THE VILLAGE SUBDIVISION  
P.O.A.D.P.  
SHEET NO. 1  
OF 1

Re: The Village Subdivision (Amended)

MDP # 473-B

The City Staff Development Review Committee has reviewed The Village Subdivision (Amended) Master Development Plan M.D.P. # 473-B. Please find enclosed a signed copy for your files. Your plan was accepted, however please note the following:

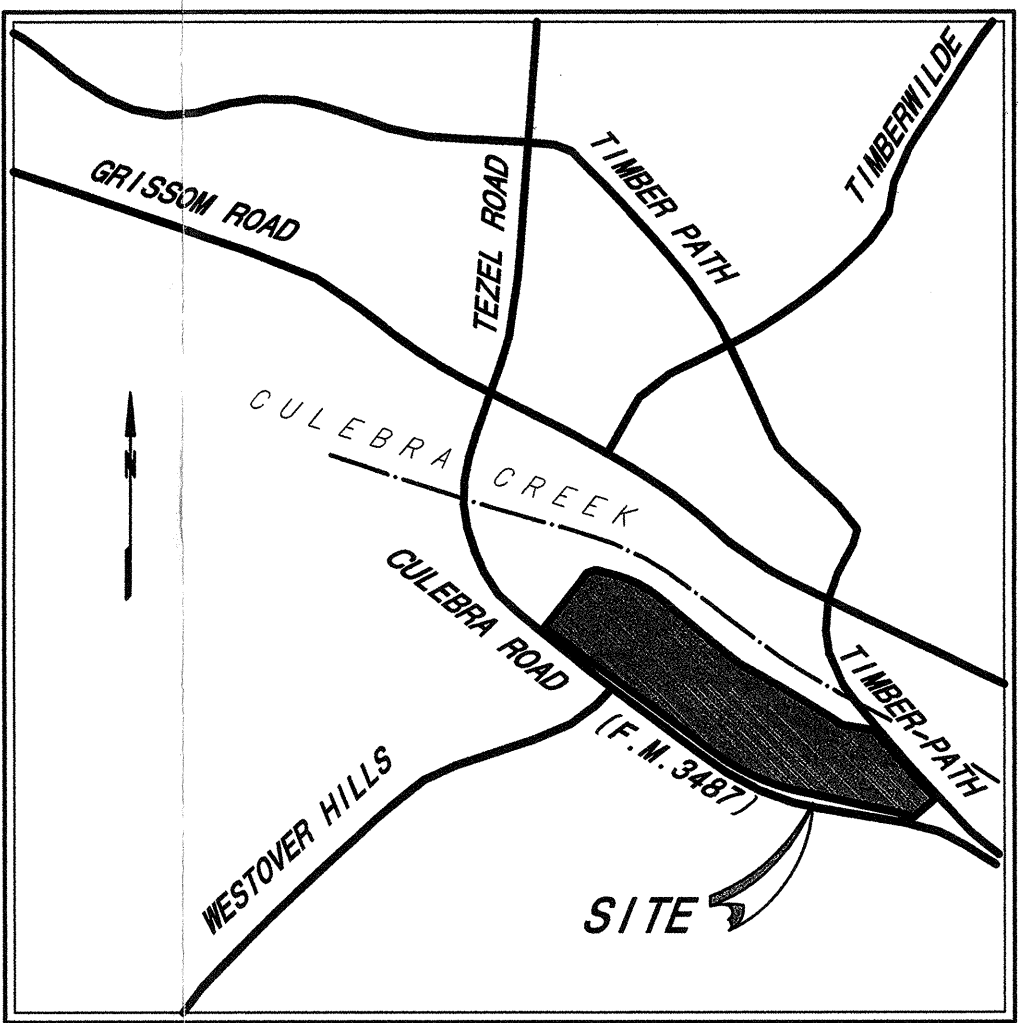
Remove the wording  
(Reserved) & show  
as Predicate Dated  
P.O.M. Only!

1. Show all proposed drainage easements and interceptor drains on the exhibit.

② Collector Section recommended to  
provide 4-11' lanes on 44'  
of paved asphalt.

- 50' MINIMUM LOT WIDTH

- 6,000 <sup>sq</sup> MINIMUM LOT SIZE

FINAL PLANS FOR APPROVAL  
Resubmittal based on comments from Drainage "SHOW  
DRAINAGE ESMITS". & Zoning Dept "Incorrect Zoning".  
We filed zoning case which passed & we lost one lot  
from original ROADP submittal due to zoning. Thanks
